Technical Service Bulletin: TSB190108

Released Date: 24-Jun-2019

New Counterbore Cutting Tool Improvement Kit

Figure 1, Counterbore Cutting Improvement Kit, Part Number 5395552.

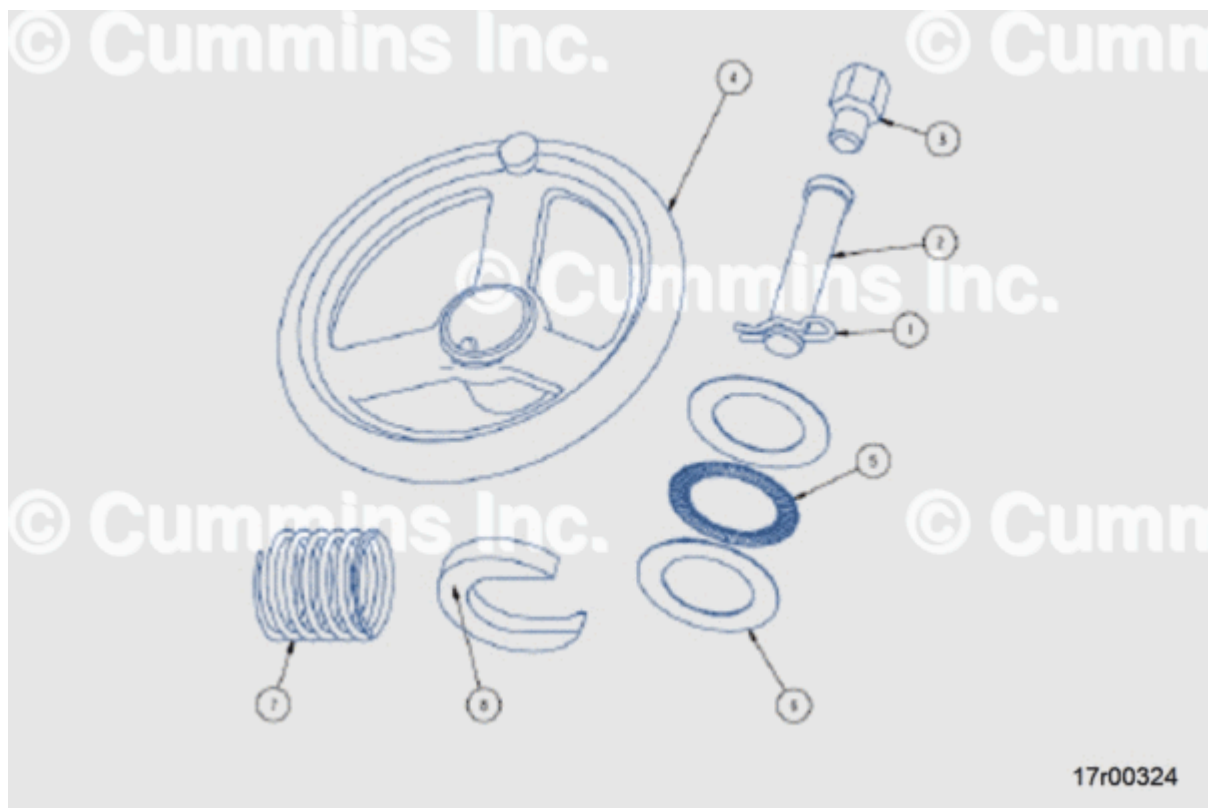
A new counterbore cutting improvement kit is available. The existing counterbore cutting tool design has been changed to reduce the stress and strain required to perform the counterbore cutting operation.

- The stop collar, Part Number 5395558, has a recessed surface and ledge that reduces the collar's tendency to back away from the drive unit during rotation. The stop collar can be used as a direct replacement for the collar that comes with the drive unit. The recessed surface on the stop collar **must** face the drive unit body.
- There are two variables that control the quality of the counter bore manual machining operation this counterbore cutting improvement kit improves:
 - Cutter bit down pressure
 - Cutter bit rotational consistency
- The spring pack will generate consistent down pressure. No manual down pressure will be required.
